Work Order ID 91780

Item Name: Crosstube Turning Detail

DART AEROSPACE LTD	Work Order:	91780
Description: Crosstube Assembly (412 High Aft)	Part Number:	D412-664-243
Inspection Dwg: D412-664-243 Rev: E		Page 1 of 2

DRAWING NO. D412-664-243	TITLE CROSSTUBE ASSEMBLY (412 HI AFT)	REV. E	DART AEROSPACE LTD ENGINEERING ORDER		D.E.O. NO. D412-664-243-E-1	SHEET NO. SHEET 1 OF 2	SCALE NTS
DRAWN	CHECKED	MFG. APPR.	APPROVED	DE APPR.			
DATE 11.03.31	DATE 11/03.31	DATE 11.03.31	DATE 11/03.31	DATE 11-03.31

**D412-664-243
ASSEMBLY DETAIL**

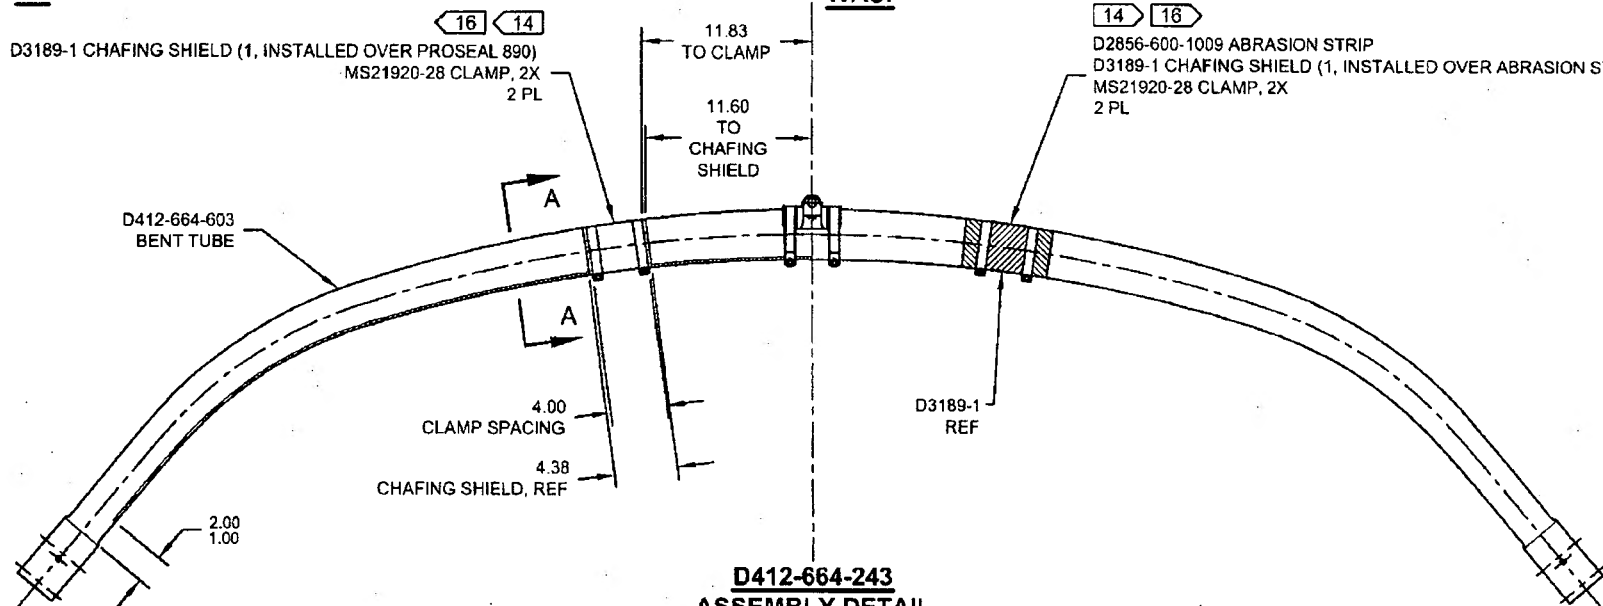
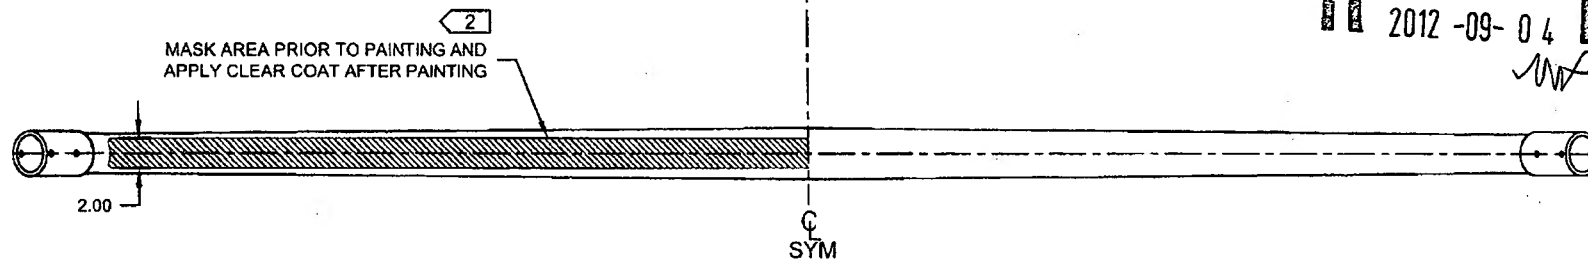
REMOVED ABRASION STRIP IN FAVOR OF A THIN LAYER OF PROSEAL 890. UPDATE INSTALLATION OF CHAFING SHIELDS AND REDUCE TORQUE TO 40-50 IN-LBS. THIS ENGINEERING ORDER SUPERCEDES DEO D412-664-243-E-1.

IS:

D3189-1 CHAFING SHIELD (1, INSTALLED OVER PROSEAL 890)
MS21920-28 CLAMP, 2X
2 PL

WAS:

D2856-600-1009 ABRASION STRIP
D3189-1 CHAFING SHIELD (1, INSTALLED OVER ABRASION STRIP)
MS21920-28 CLAMP, 2X
2 PL

MASK AREA PRIOR TO PAINTING AND
APPLY CLEAR COAT AFTER PAINTING
